AIRAC
AIP
Supplement 98/25
16 OCT 2025

A D : MUAN/Muan INTL(RKJB)

RWY 19 THRESHOLD DISPLACED BY 300 m

4. DIAGRAM

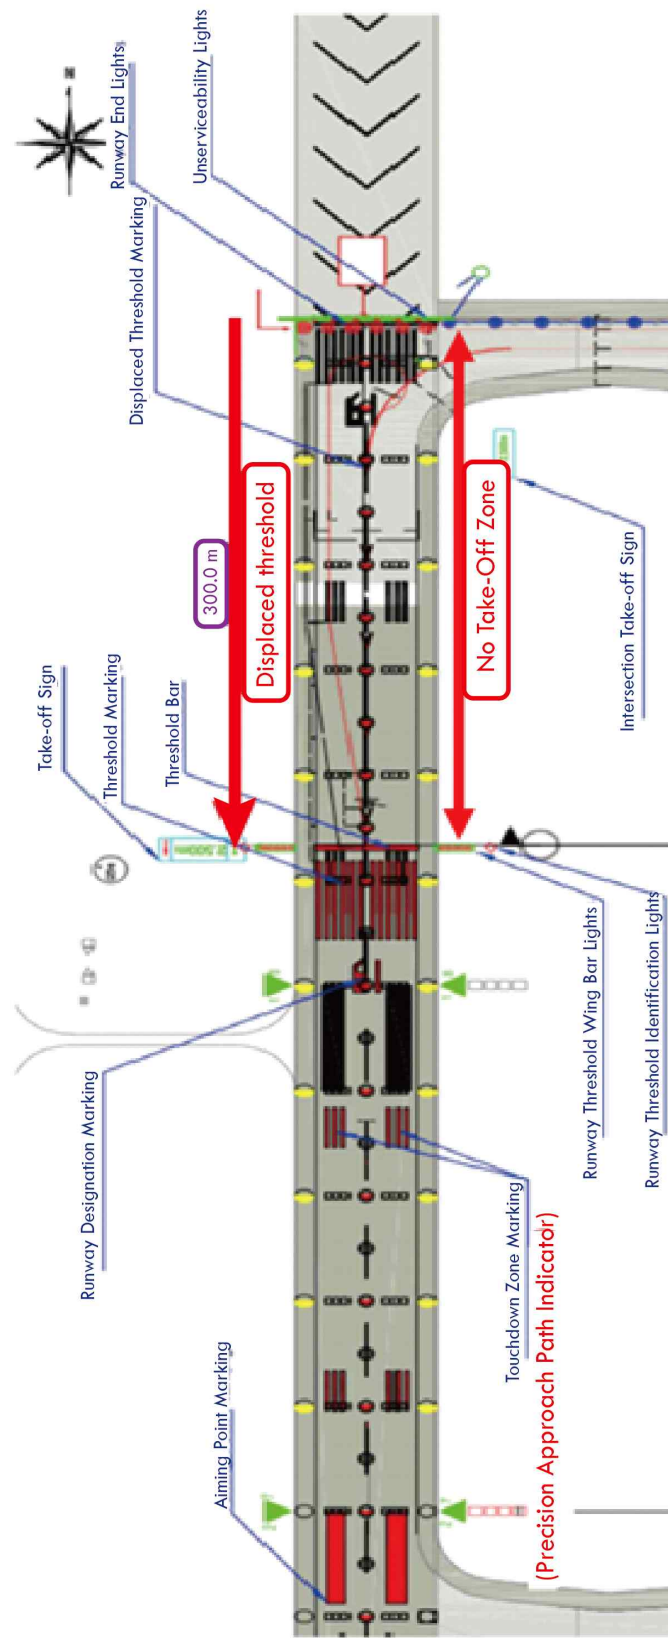
RWY 19 landing threshold will be displaced by 300 m.

- (1) Temporary sign for TORA 2 500 m and intersection take-off sign when entering RWY 19 from TWY E1 will be installed.
- (2) To avoid aircraft blast, all departure aircraft for RWY 19 shall start take-off at displaced threshold("T" point).
- (3) Any change to the contents of these pages will be notified by NOTAM.
- (4) TDZL will be U/S.

Intersection take-off sign when entering RWY 19 from TWY E1

Temporary sign for TORA 2 500 m
